HURON-CLINTON METROPOLITAN AUTHORITY
FLATROCK DAM 2008 REPAIRS

AS-BUILT ("A.B.") DRAWING NOTES	JRR	By	Appd.	01.10
Revision				MM.DD.YY
BID SET				05.08
OWNER REVIEW				03.08
QA/QC (95%)				02.08
ROAD COMMISSION SUBMITTAL (WCOPS)				01.08
REVISIONS PER MDO				12.13.07
PERMITS (90% SET)				10.31.07
60% REVIEW				07.07.10
Issued		By	Appd.	MM.DD.YY

SOIL EROSION CONTROL AND MISC. DETAILS

**RIGHT SIDE, LOCK
DEMOLITION PLAN**

RECONSTRUCTION DETAILS AND SECTIONS I

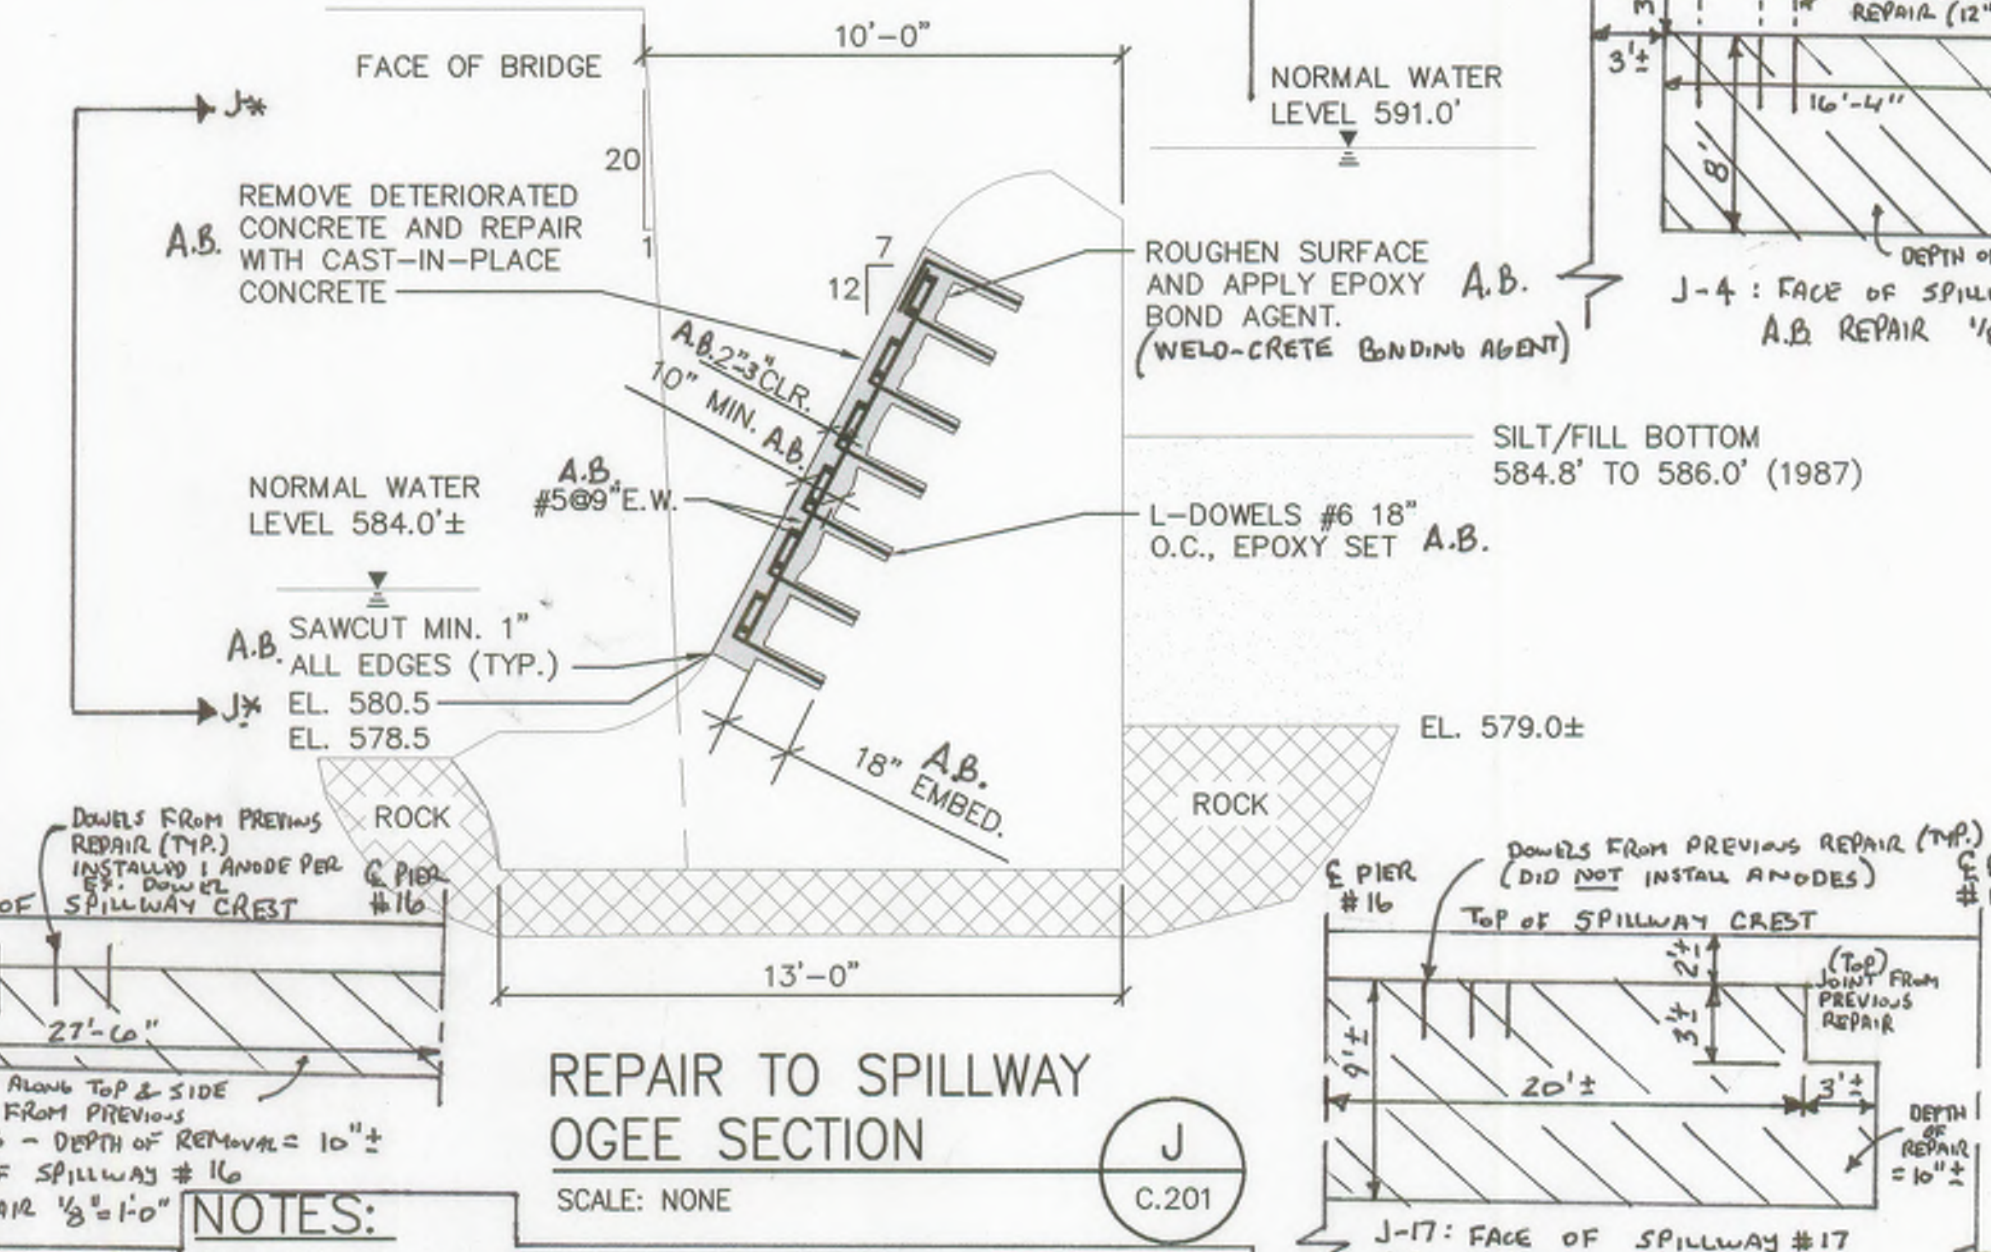
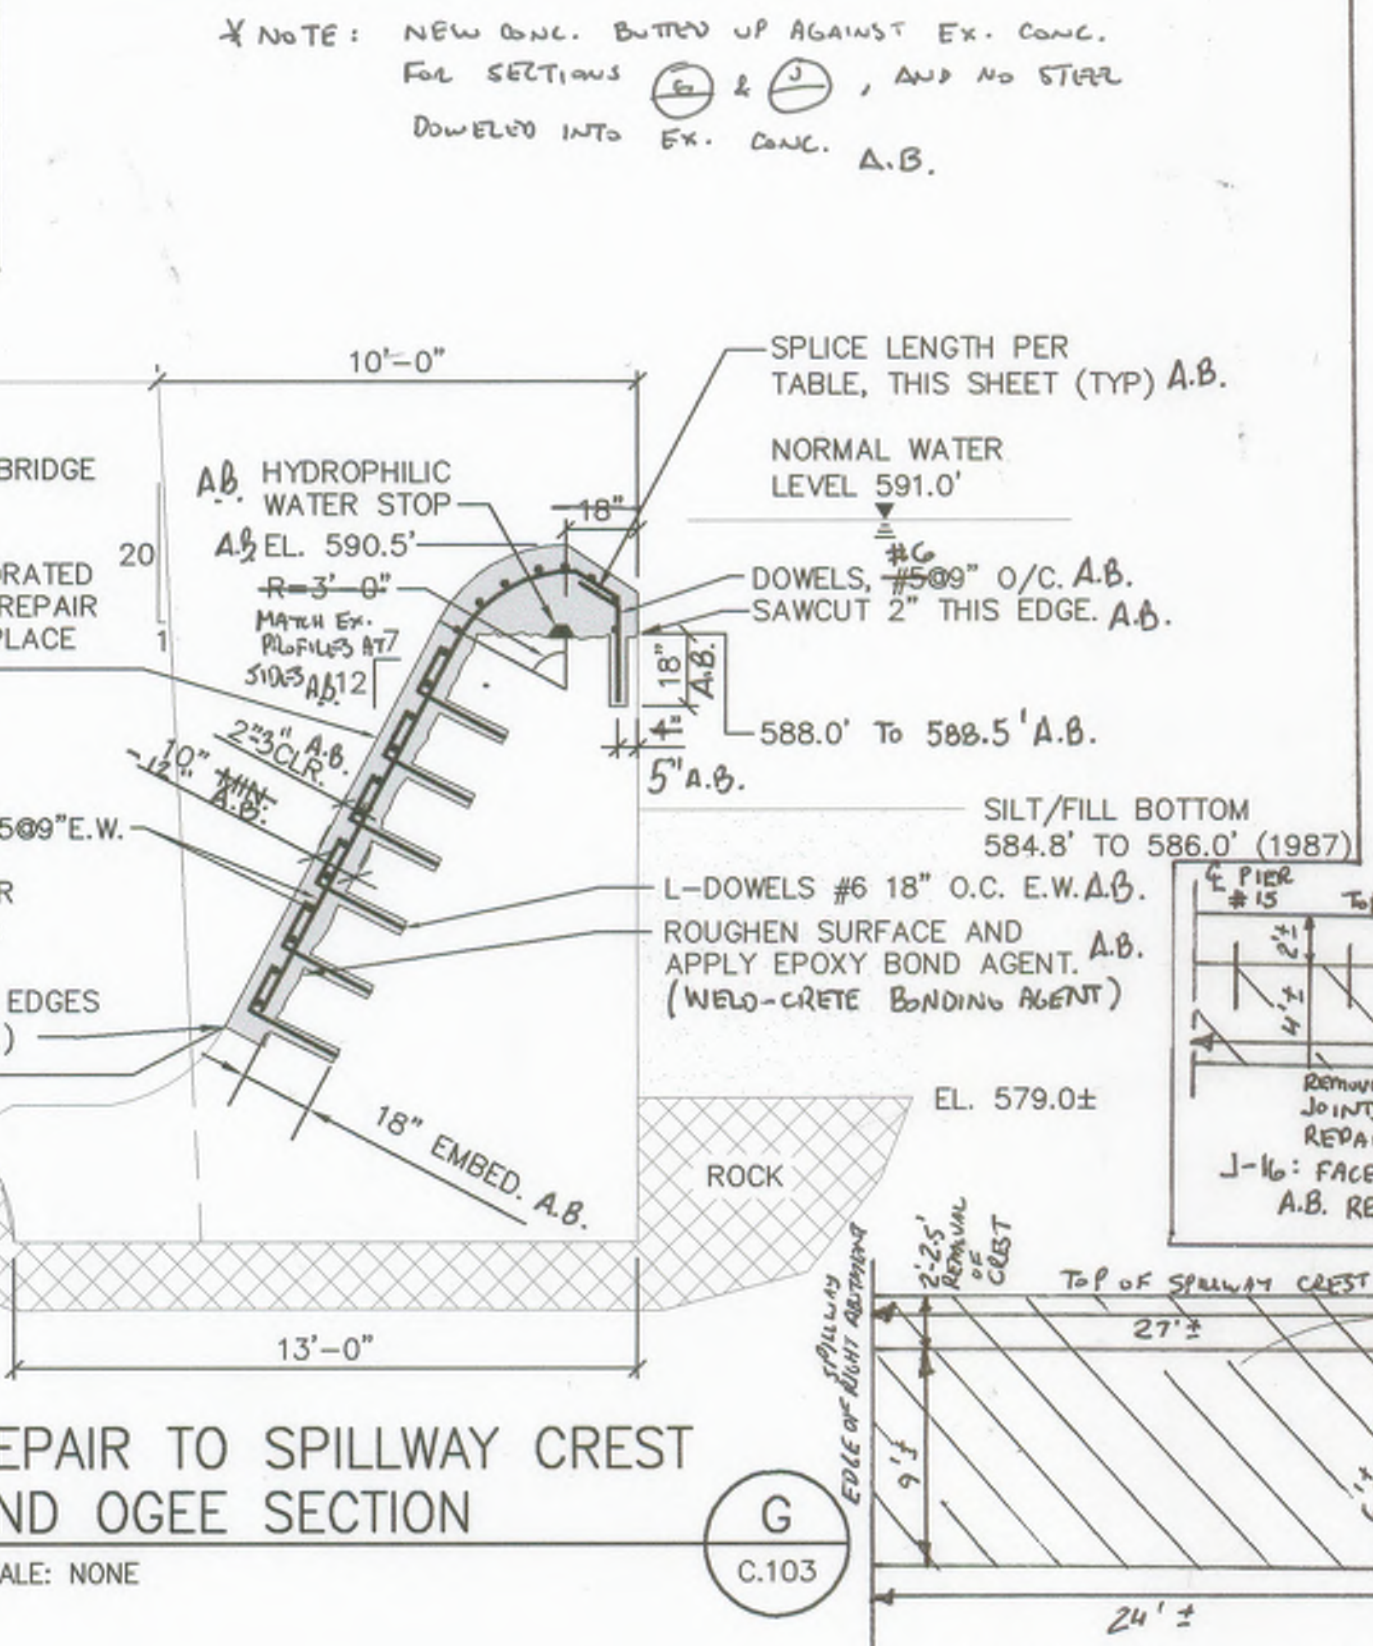
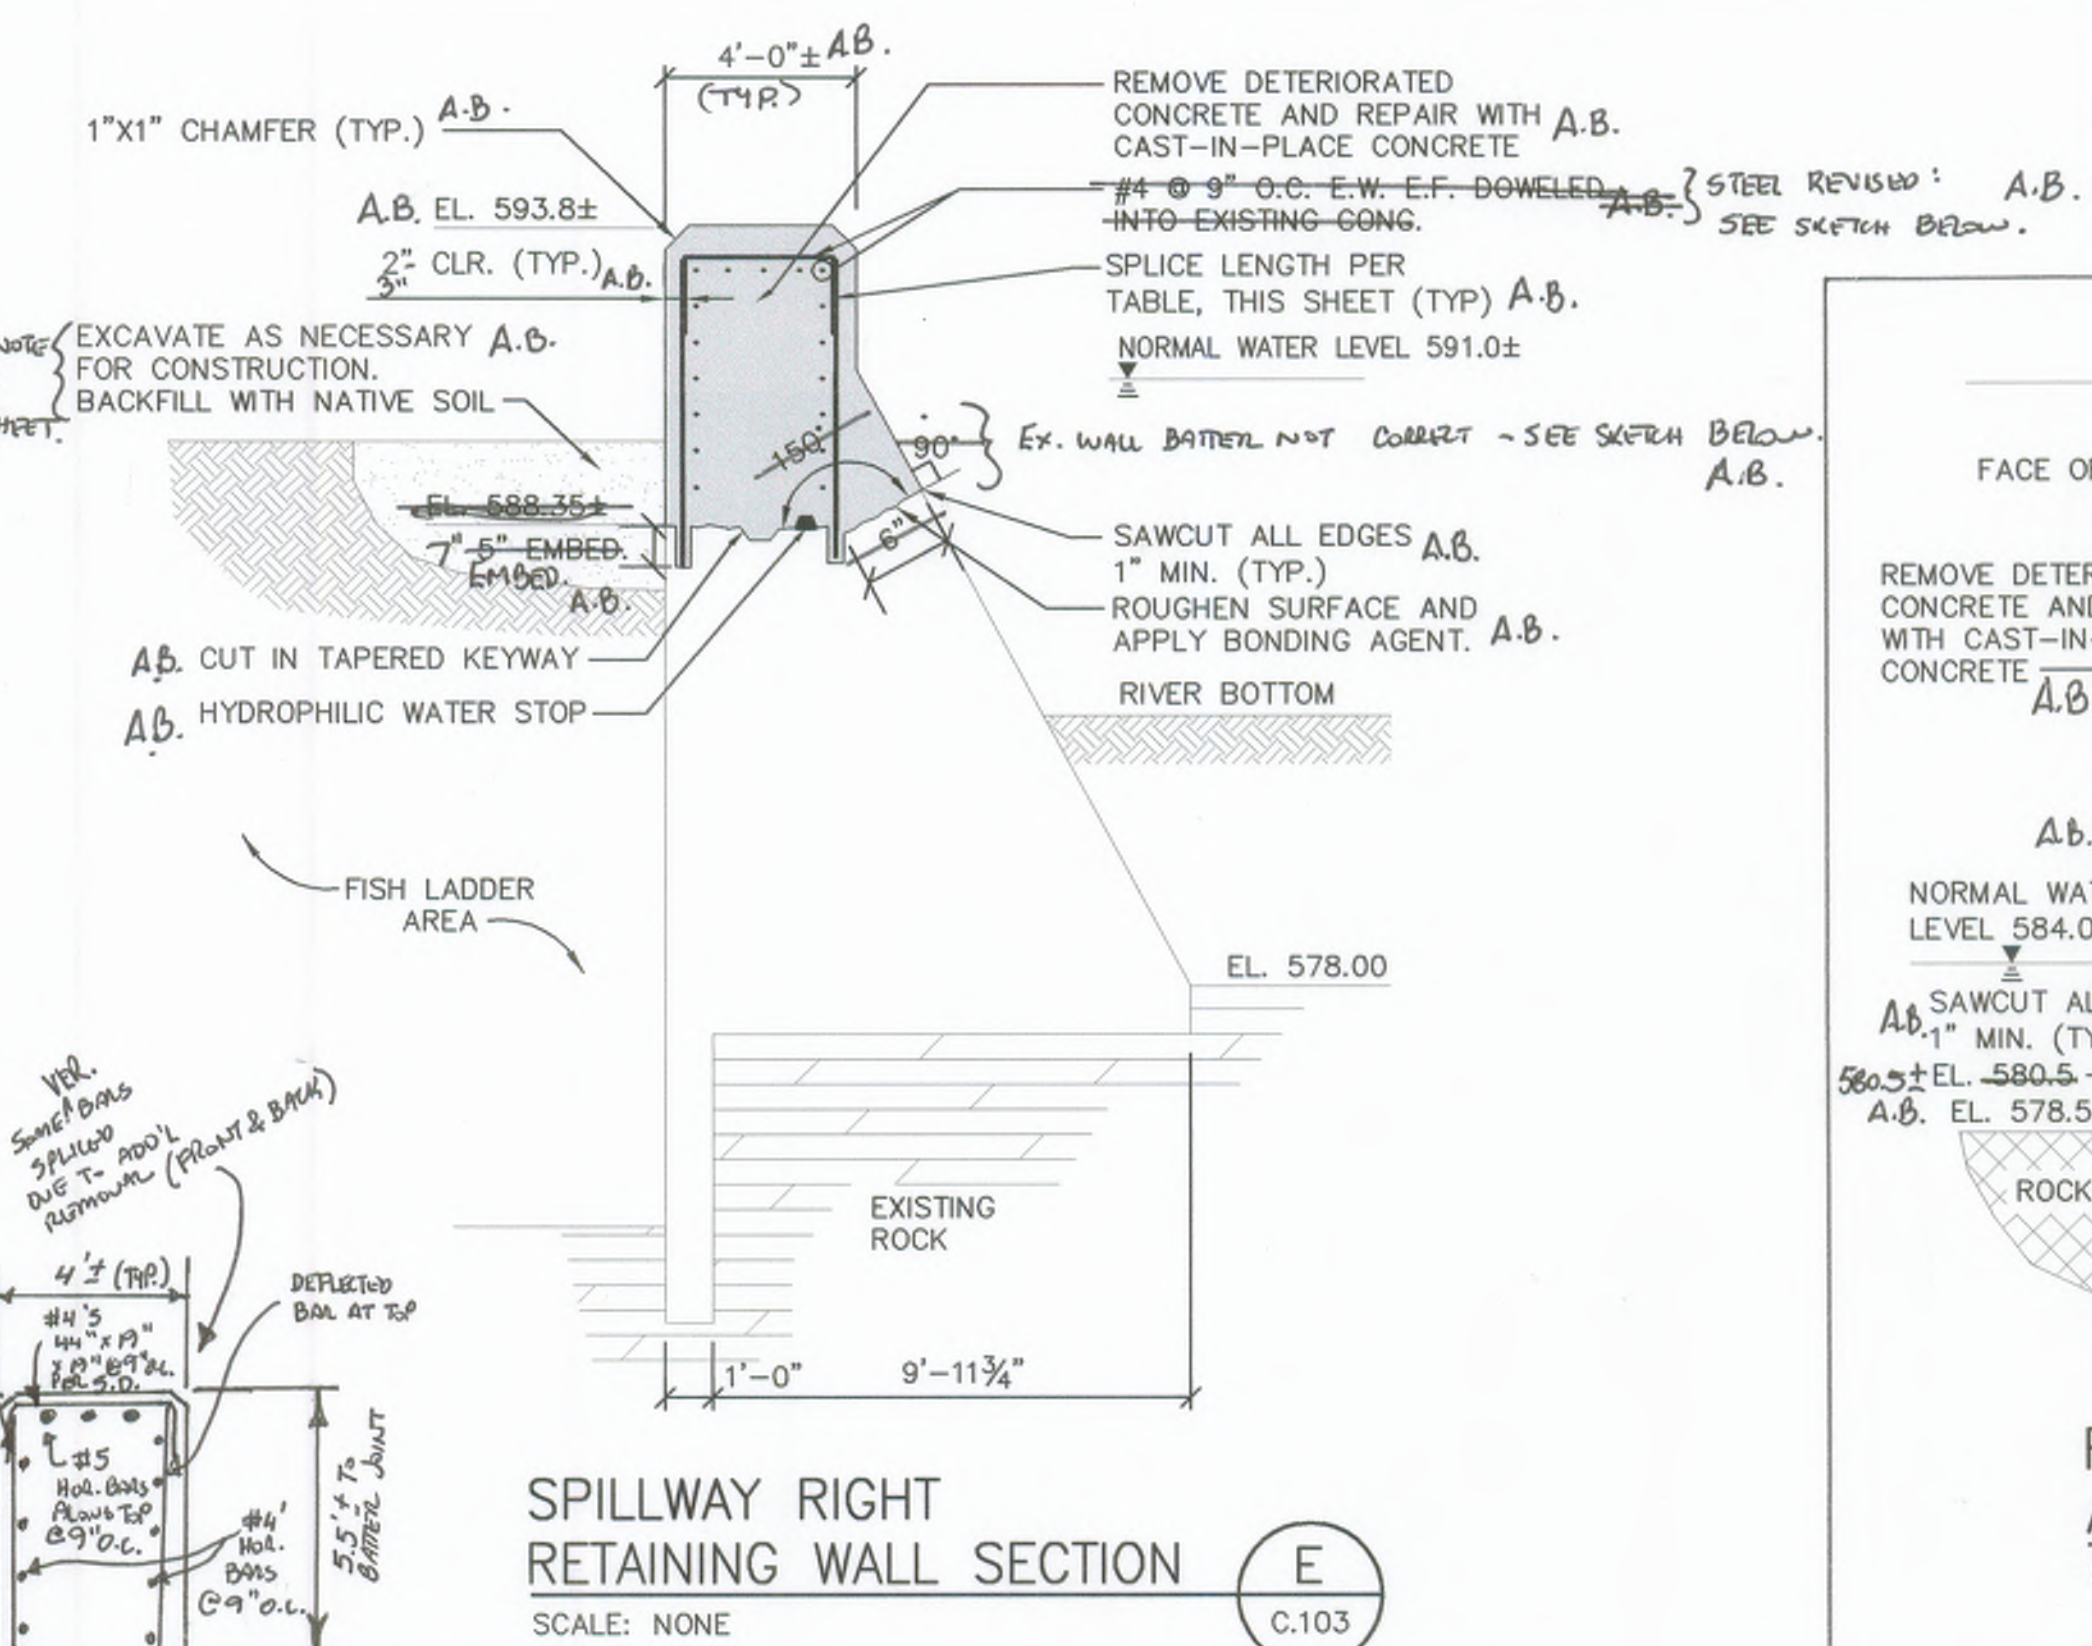
ADDITIONAL REBAR: 500 LBS. 330 LBS. A.B.
ADDITIONAL DOWELS: 440 EA. 40 EA. A.B.

(DOWELS ON 2 SIDES
& BOTTOM ONLY, NO DOWELS
INTO EX. BRIDGE BEAM ABOVE) A.B.

1. (APPLY TO ALL CONCRETE REPAIRS)
1. ROUGHEN ALL CONTACT SURFACES OF EXISTING CONCRETE TO CSP 6 OR 7 AS ESTABLISHED BY THE INTERNATIONAL CONCRETE REPAIR INSTITUTE (OR 1/8" ± PROFILE). CLEAN EXISTING REBAR. TREAT ALL REBAR AND CONCRETE CONTACT SURFACES WITH SIKKA ARMATEC 110. A.B. NOTE: HEMA ENHANCER ALLOWED W/ WELD-CRETE BONDING AGENT SINCE ITS OPEN TIME IS 7-10 DAYS, VS. SIKKA 10 OF 16 HOURS. DUE TO LOGISTICS OF SETTING REPAIRS & POURING CONCRETE, FOR REPAIR SECTIONS B, C, & J ONLY, (REBAR NOT TREATED PER STANTEC).

2. UNLESS OTHERWISE SHOWN, #4 DOWELS SHALL BE EMBEDDED 5" ON EDGE AND 8" ON FACE; #5 DOWELS 7"; AND #6 DOWELS 18". ALL DOWELS SHALL BE EPOXY SET WITH MULTI-HIT 150 OR HIT ICE. A.B. OR AS SHOWN ON APPROVED STEEL SHOP DRAWINGS. A.B. HILTI HIT RE 500 (EXCEPT A FEW LOCATIONS WHERE A BAR WAS ADDED PRIOR TO A.B., THEN, HIT 150 WAS USED FOR QUICKER CURE TIME).
